**ADDENDUM NO. 1**

**July 23, 2026**

The Solanco Area School District | New District Administration Offices & Turf Fields  
CRA Project No. 3706

1 OVERALL FIRST FLOOR PLAN  
1/8" = 1'-0"

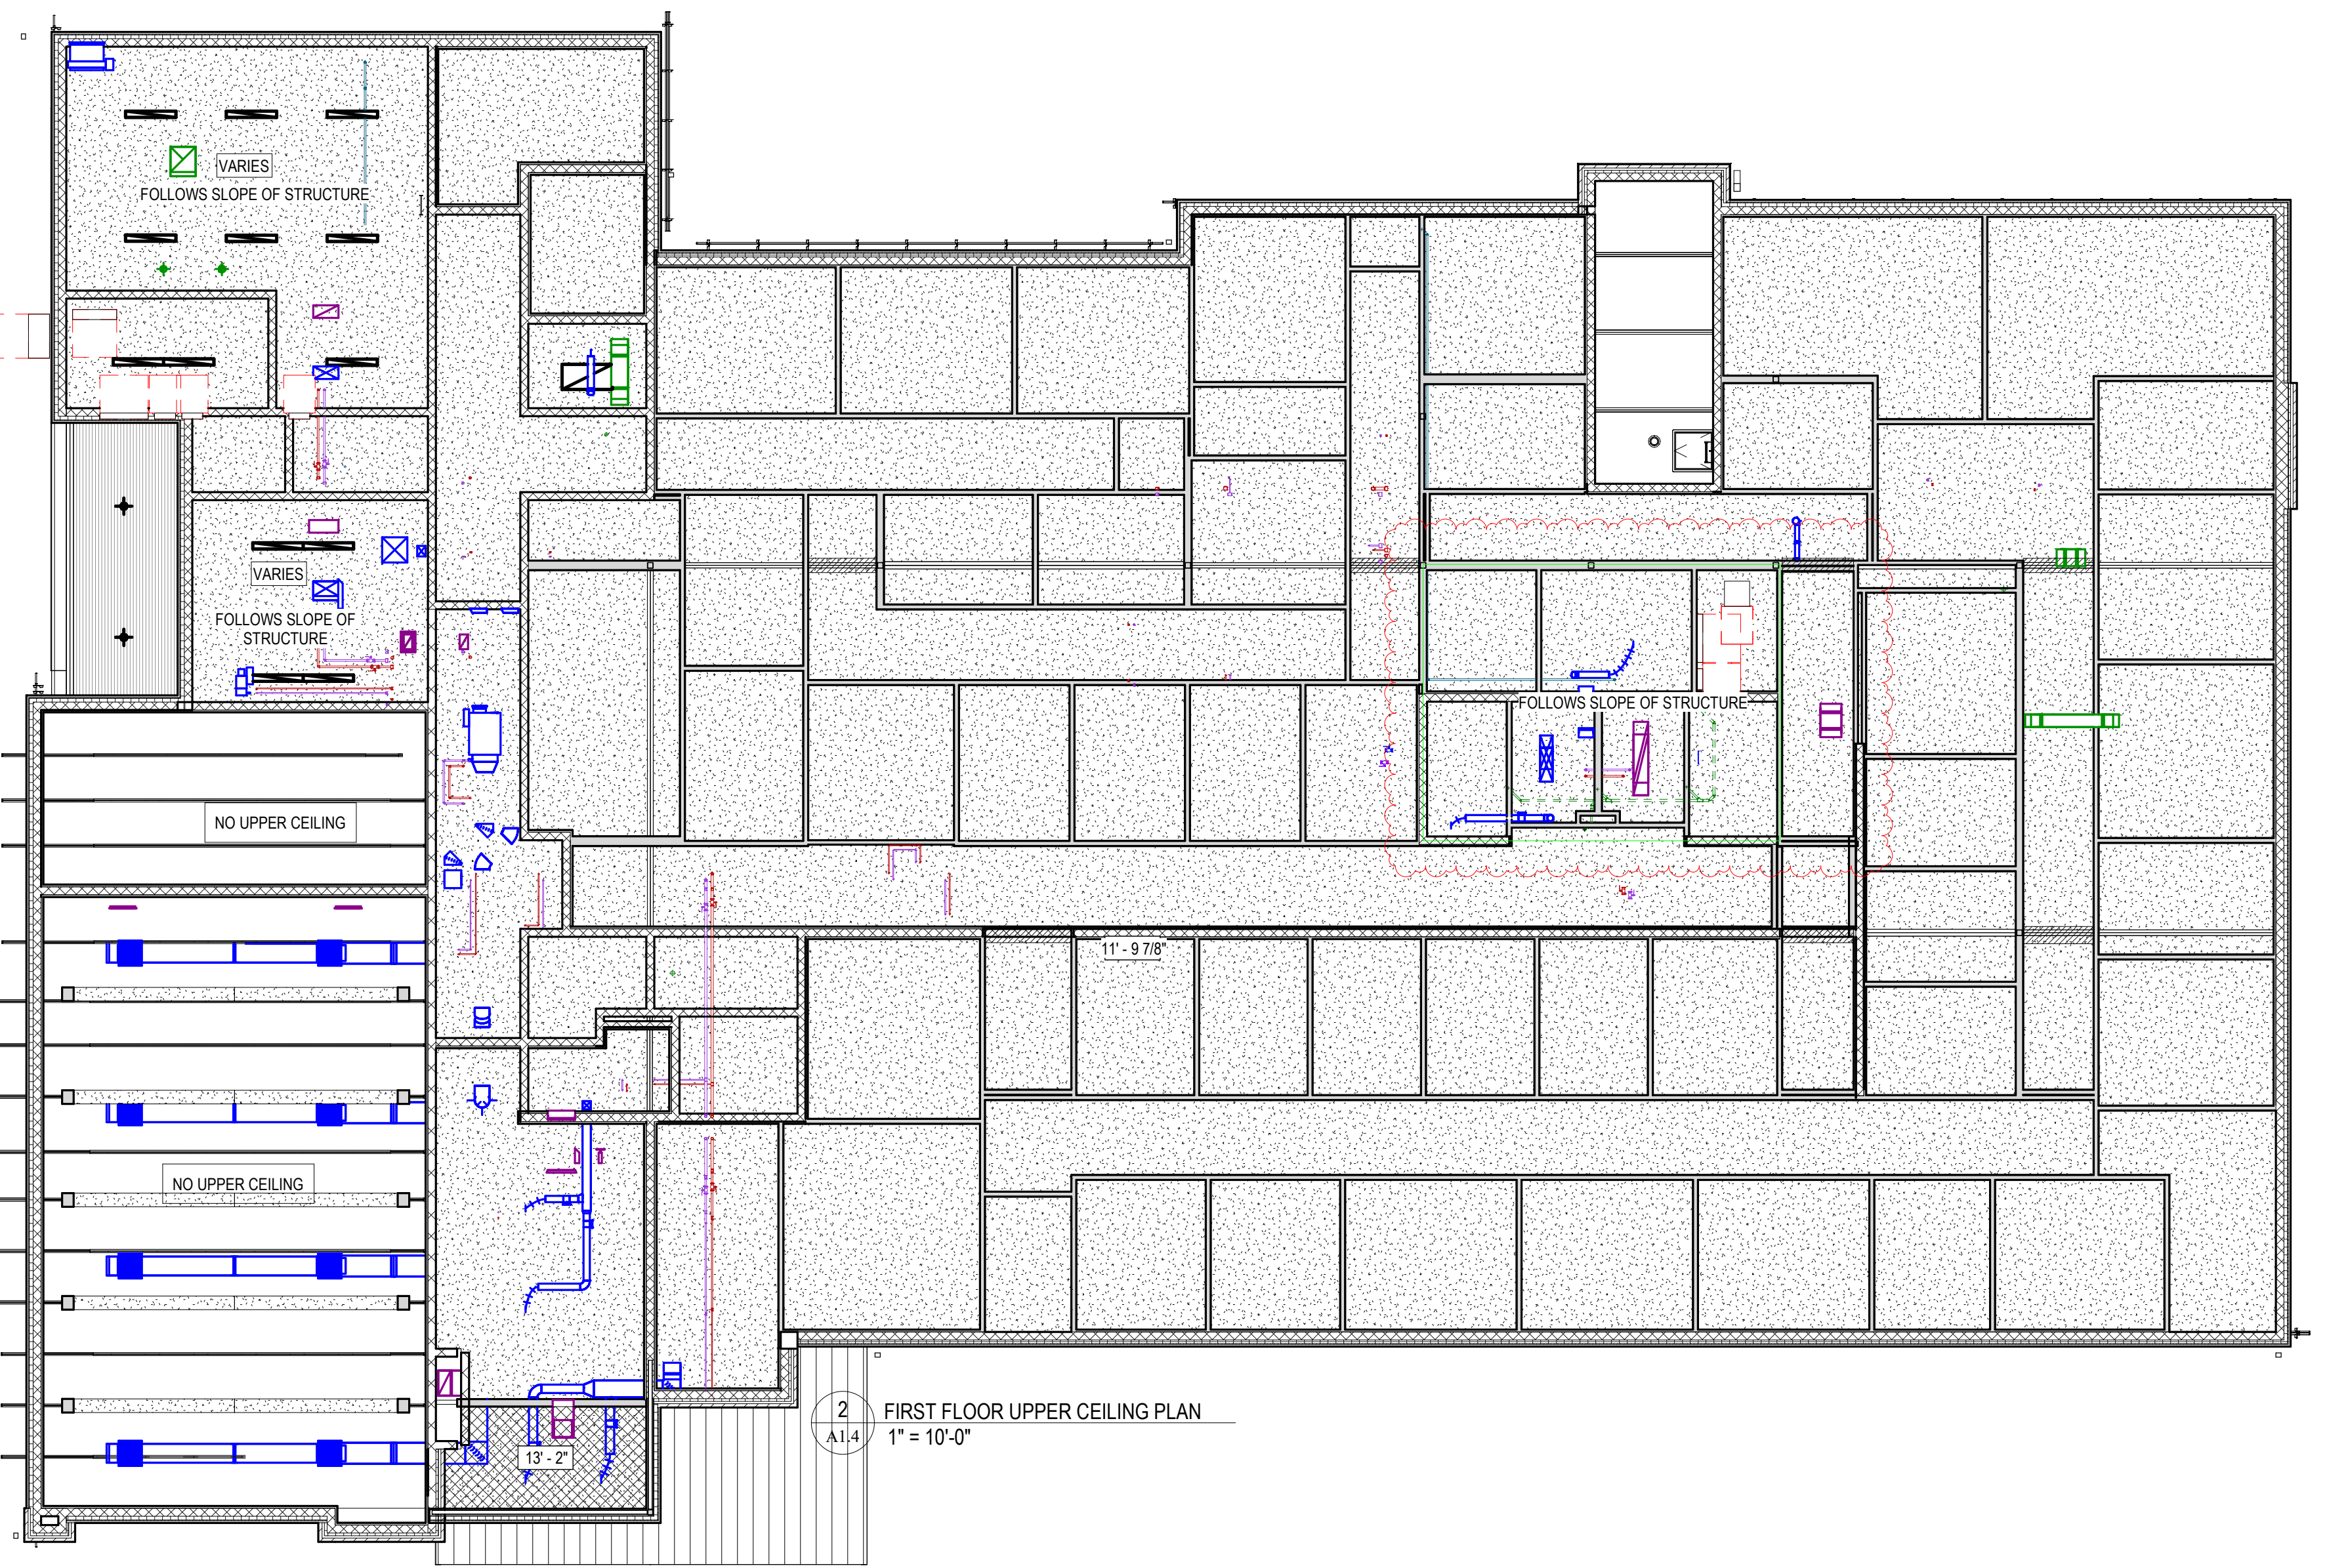
1. **REVISE** dimensions in receiving area.
2. **REPLACE** sheet in its entirety

FIRST FLOOR REFLECTED CEILING PLAN

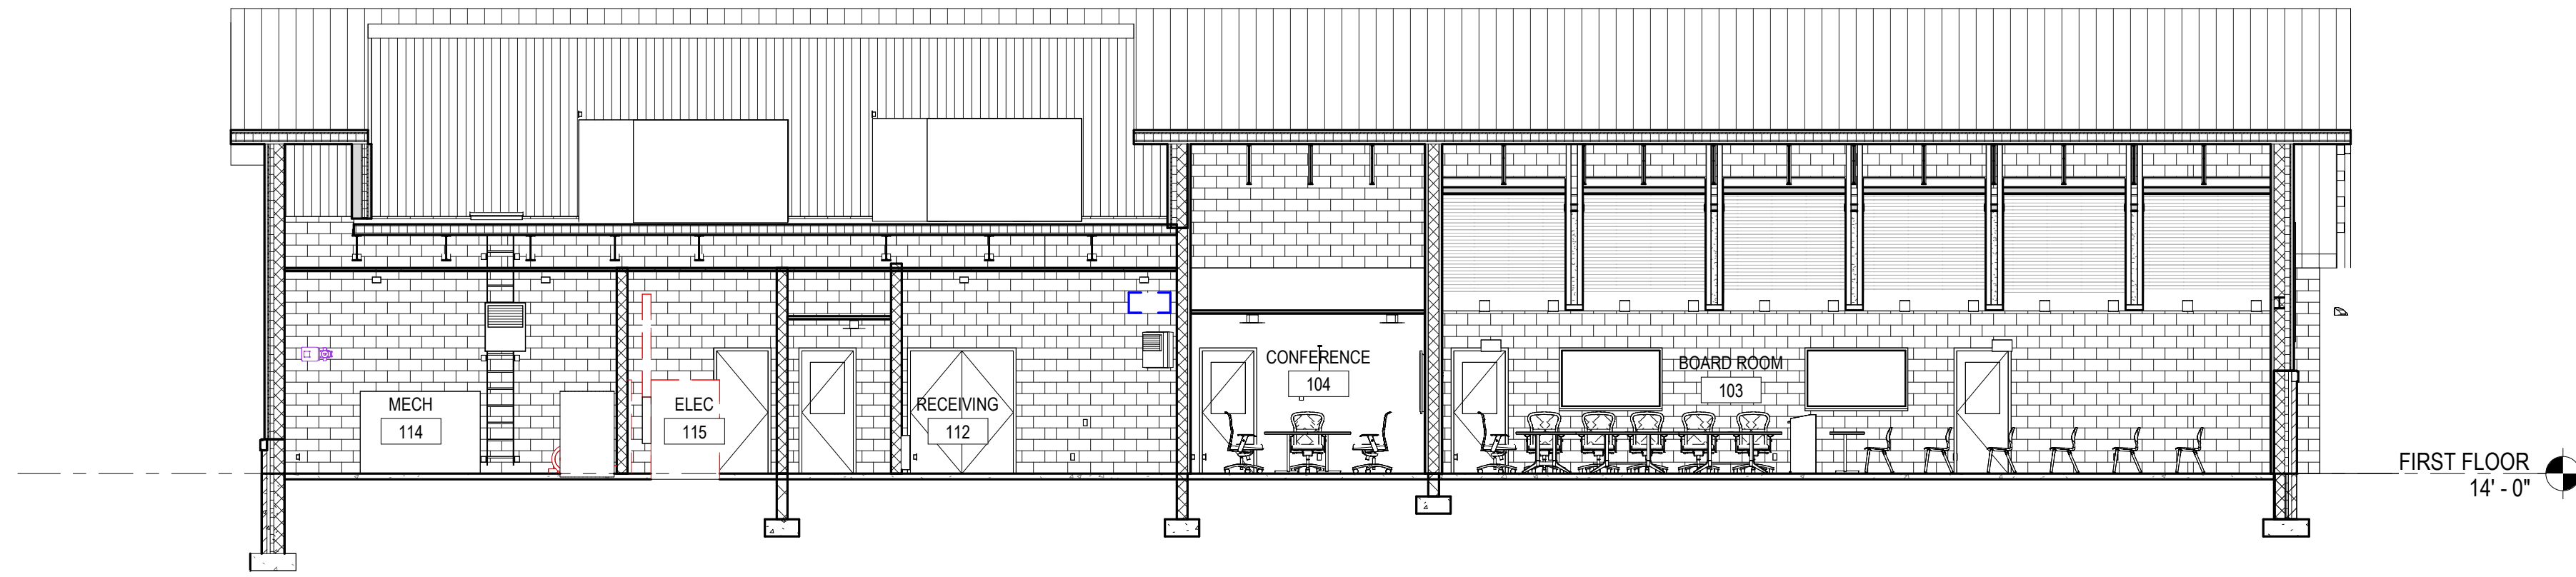
1. **ADD** details 3-4/A1.4.
2. **REPLACE** sheet in its entirety

PROJECT  
3706  
A3.1

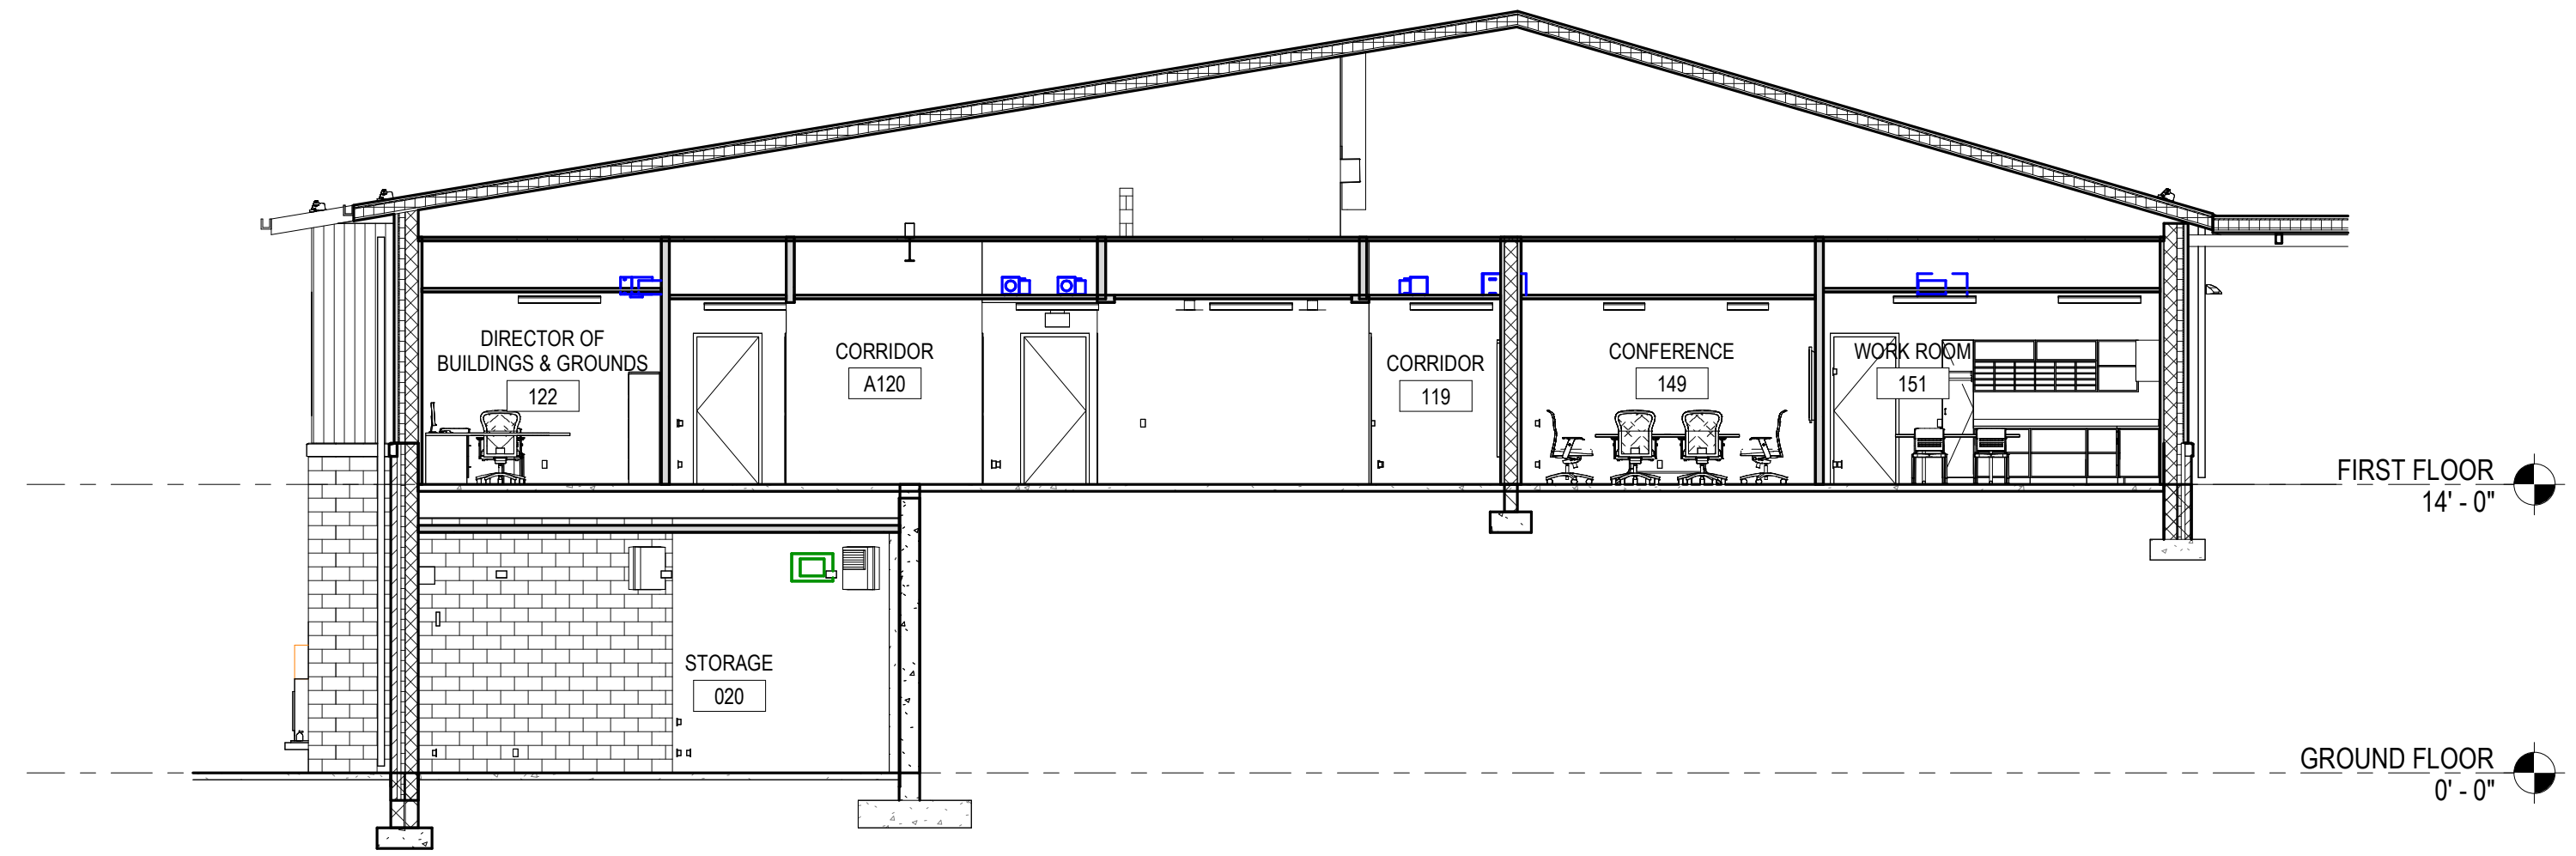
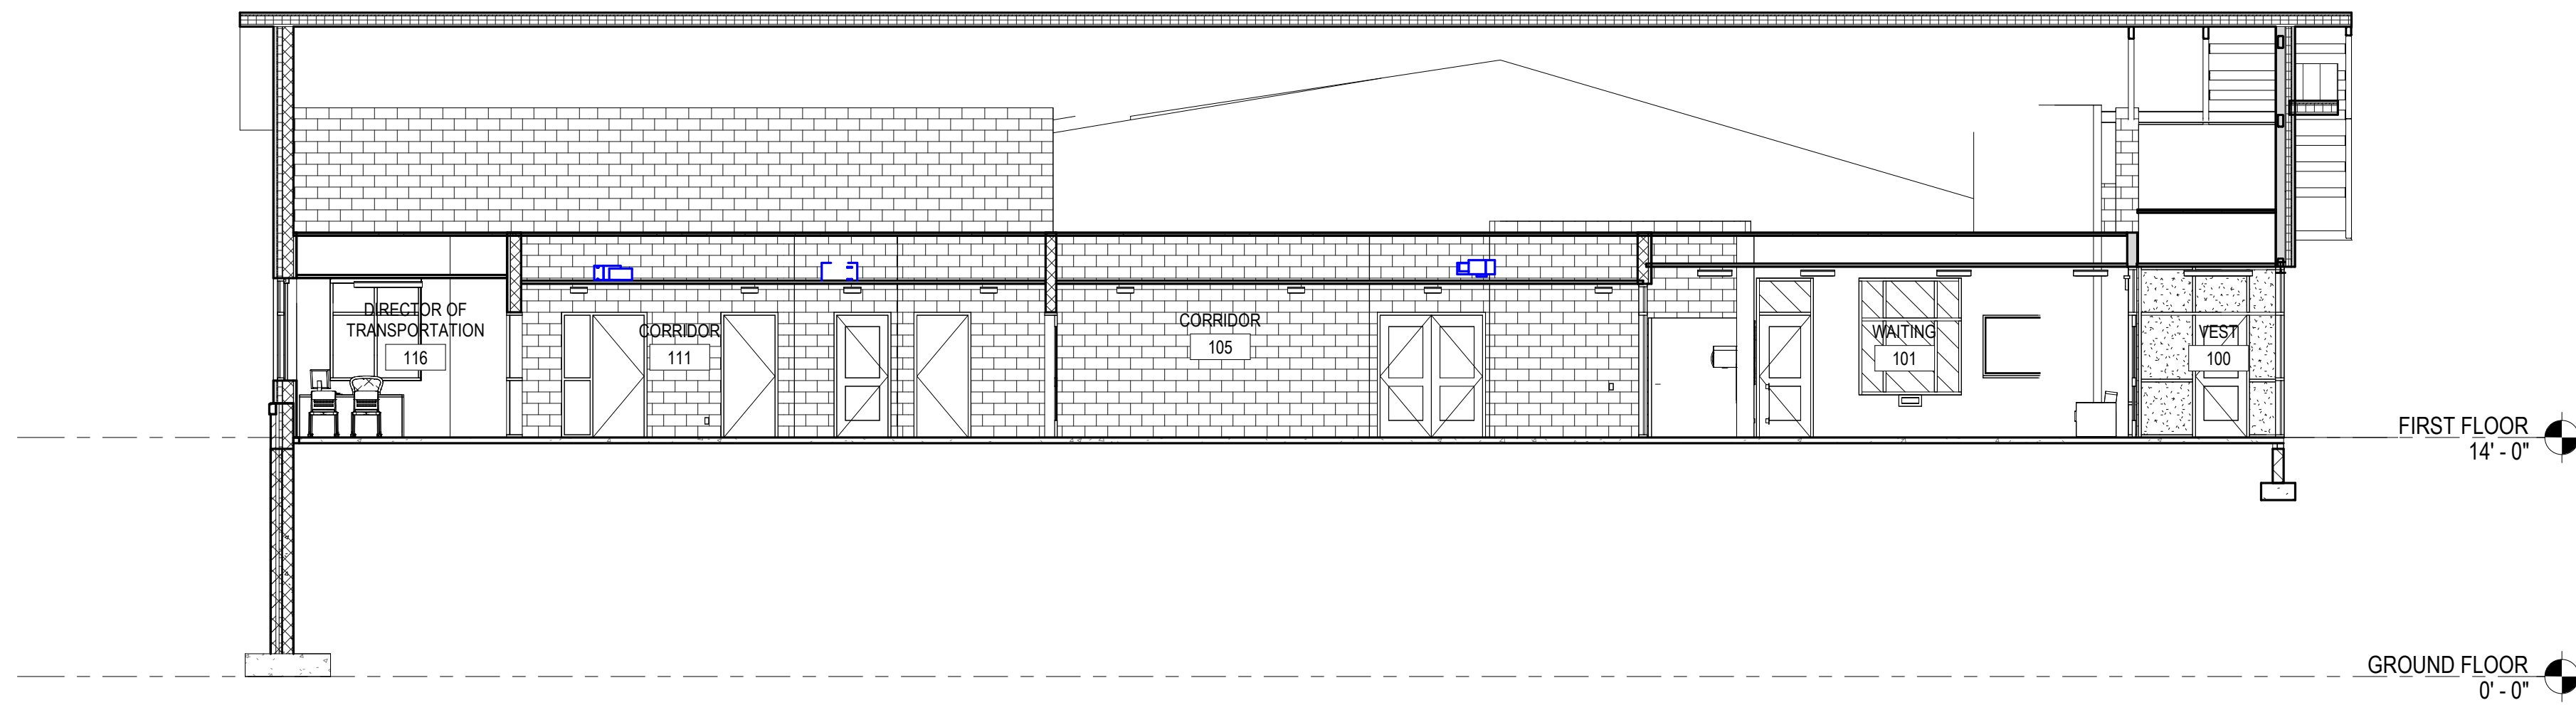
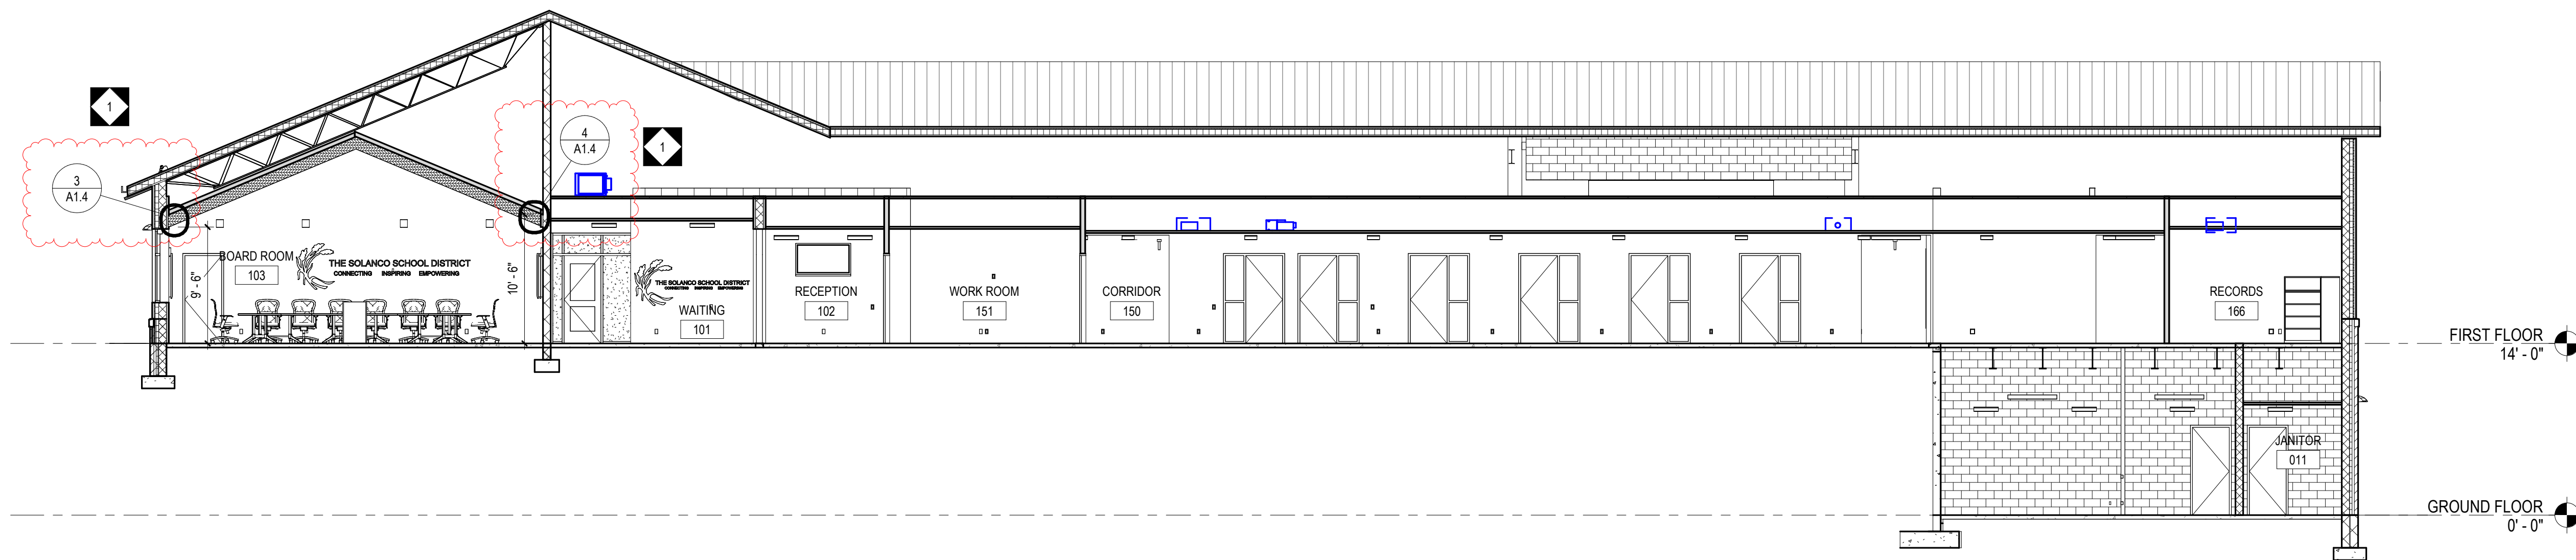
1. **ADD** location for details 3-4/A1.4
2. **REPLACE** sheet in its entirety
